# BEFORE THE PUBLIC UTILITY COMMISSION OF OREGON

Docket No. LC 75

2021 Integrated Resource Plan.

Staff's Final Comments

Figure 1: Avista's response to Staff DR 64, peak day methodology, 99% probability versus historical coldest day<sup>2</sup>

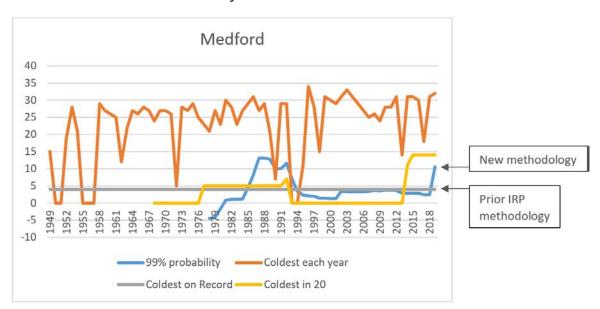
would improve accuracy. Staff DR 64 asked about the Company's use of the normal distribution for modeling weather. Figure 1 reproduces Avista's response to Staff DR 64 for Medford:

Figure 1 shows that for the Medford area, the new 99 percent probability methodology results in an 11 degree peak day, which is warmer than the prior IRP methodology of coldest on record, 4 degree peak day. Staff concurs with the Company that the new peak day methodology better accounts for weather trends from recent years that may be more representative of the future, and thanks the Company for the additional detail of the methodology that it provided in its Response Comments.

Staff appreciates the additional information the Company has provided on this topic and the Company's general willingness to explore alternatives in the future. Staff does not have any outstanding concerns about the Company's peak day methodology and looks forward to any future discussions in this area.

Figure 2: Residential UPC vs. HDD for Medford January Weekdays<sup>3</sup>

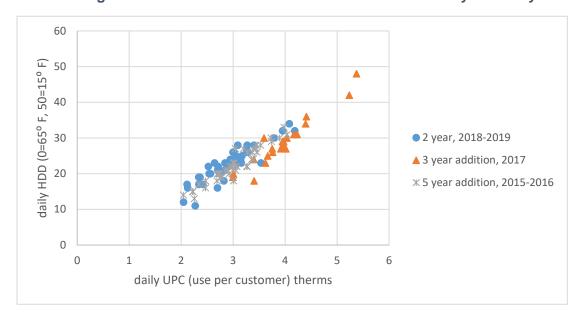
In Opening Comments, Staff recommended that the Company switch from three years to five years of input data for its UPC forecast because Staff believes it is beneficial to use more years of input data. As presented in Opening Comments, Staff believes that the following figure demonstrated that using three years of data instead of five years is not more accurate, thus, using the maximum amount of data is a better approach.

Avista did not reply to Staff's UPC forecast recommendation in its comments.

Staff reemphasizes that switching from three years to five years of input data is beneficial and recommends that future IRP updates and the next IRP employ this approach.

Recommendation 1: In the next IRP, use at least five years of historic data for modeling use per customer.

Figure 3: Percent of RNG customers would select at \$1.60, \$1.10, and \$0.70/therm as compared to conventional gas at \$0.60/therm <sup>14</sup>

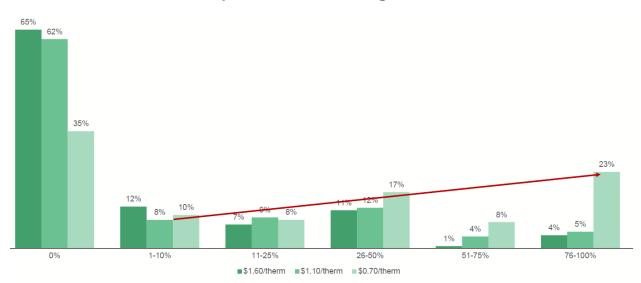
Figure 3 below comes from a marketing study conducted for Avista in April 2019 that was submitted in response to DR 39.<sup>13</sup> It shows that the majority of Avista customers were not willing to commit to using large percentages of RNG at a price premium, but as the price decreases to \$0.70/therm, customers were increasingly interested in purchasing larger percentages of RNG.

Staff appreciates the work the company has done to understand customers' willingness to pay for RNG and thinks this information may be especially valuable in future conversations about DEQ CPP compliance and OPUC's NGFF effort. Staff sought to better understand how well these findings correlate with the behavior of Oregon customers and whether the Company anticipated these findings affecting its ability to rely on RNG to reduce GHG emissions.

Staff issued a number of DRs regarding customer preferences in Oregon to which the Company responded indicating that such studies have not been conducted. It indicated that select feedback from Oregon customers suggests that customers have an interest in emission reductions, and that they seek economical options for doing so. The Company reports that some customers, in particular institutional and commercial customers, see electrification as a cost prohibitive solution and that they have alternatively expressed an interest in RNG and offsets as a potential way to meet their carbon reduction goals. Staff recommends that prior to

the next IRP, the company conduct market research to more fully reflect Oregon customer willingness to pay for various carbon reduction strategies to inform the feasibility and potential adoption rates of possible emission reduction strategies.

Recommendation 9: Prior to the next IRP, conduct market research to reflect the willingness of Oregon customers to pay for various carbon reduction strategies. Present results at a TAC meeting.
